# AMENDMENT OF SOLICITATION/MODIFICATION OF CONTRACT

1. The specifications and drawings for Invitation No. DACW64-03-B-0006, Dredging, Middle Reach, Neches River Channel in Jefferson and Orange Counties, Texas, Sabine-Neches Waterway, Texas, advertised 20 December 2002 and for which bids are scheduled to be opened 21 January 2003, are hereby modified as follows:

TO BE ADDED TO SHEET 3 OF 42

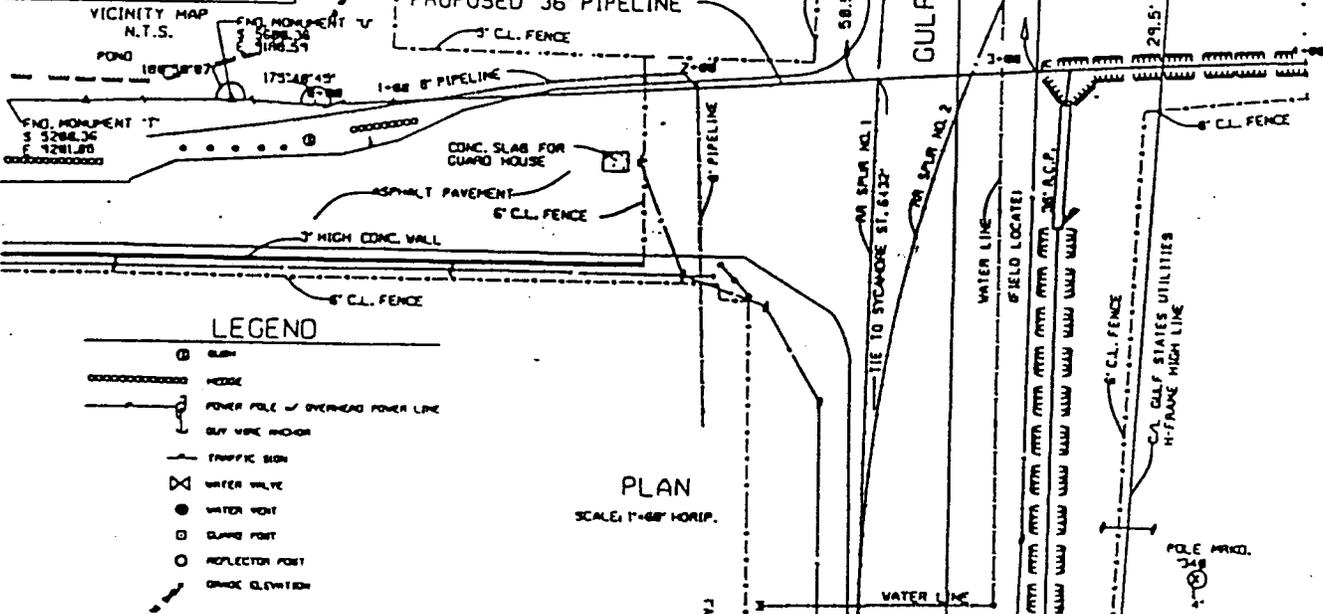
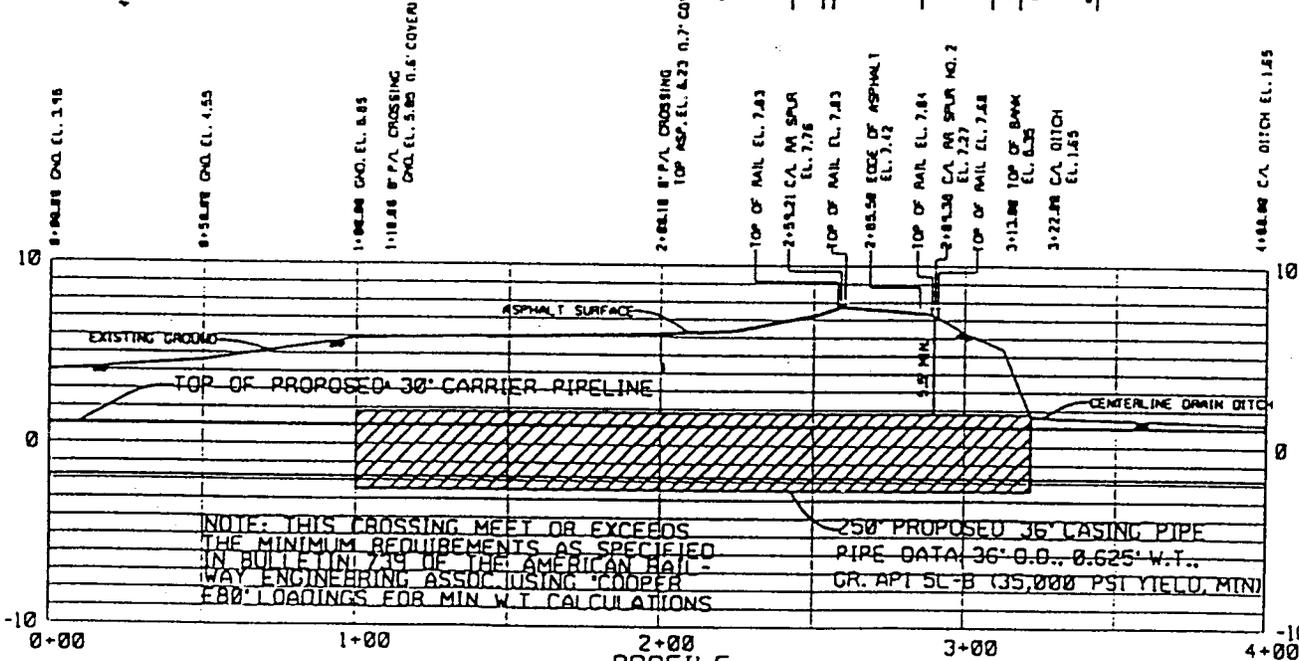
(1) Sheet 3 of 42. - The enclosed SKETCHES NOS. 1 through 4 shall be added to and become part of Sheet 3 of 42.

SKETCH No.2

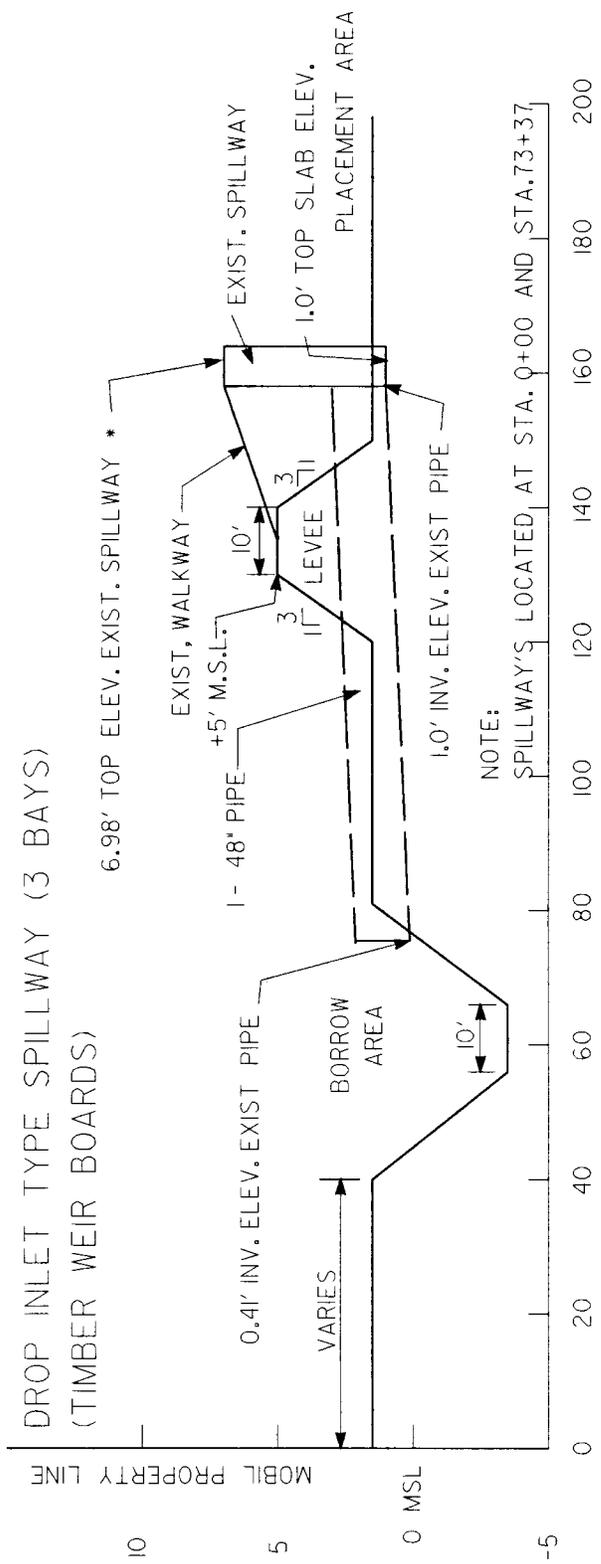
TYPICAL LEVEE SECTION  
 PLACEMENT AREA No.25B  
 (REAR PORTION)

\* FROM STA. 0+00 TO STA. 103+00  
 AND STA. 143+00 TO STA. 155+62

TYPICAL LEVEE SECTION  
 PLACEMENT AREA No.25B  
 (REAR PORTION)

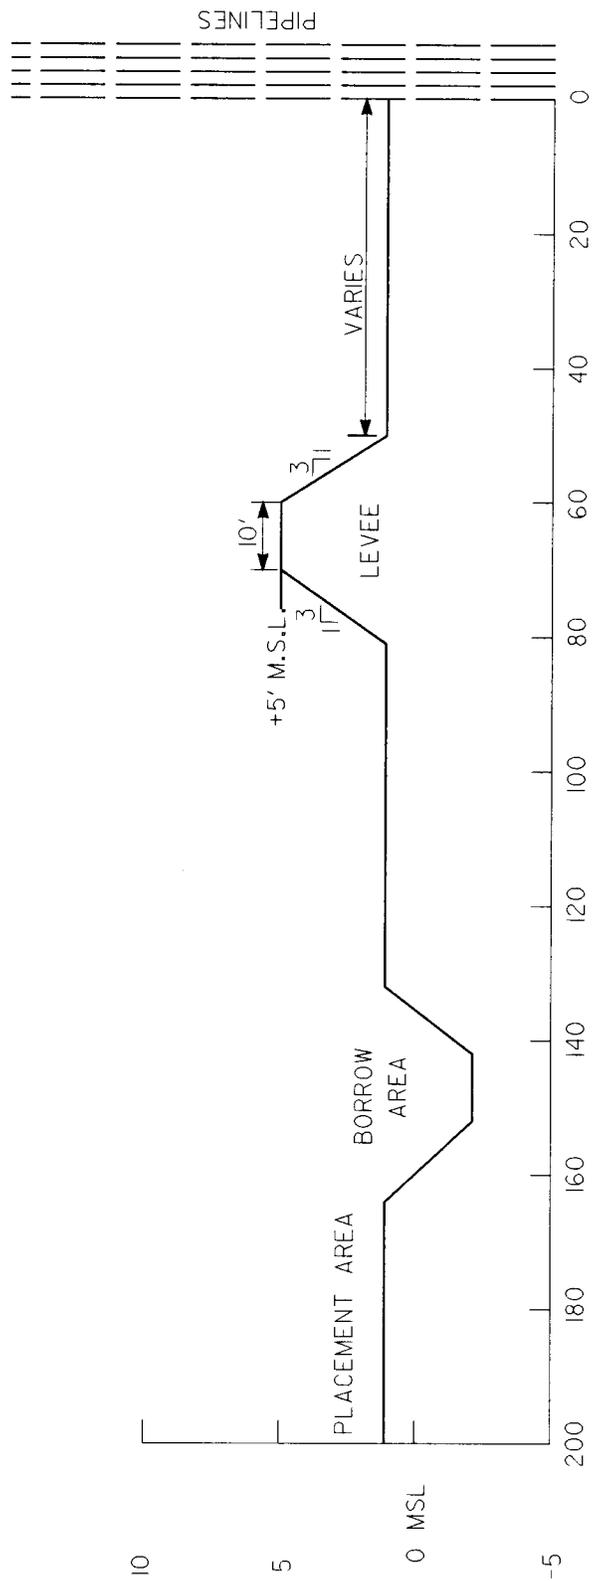
\* STA. 103+00 TO STA. 143+00
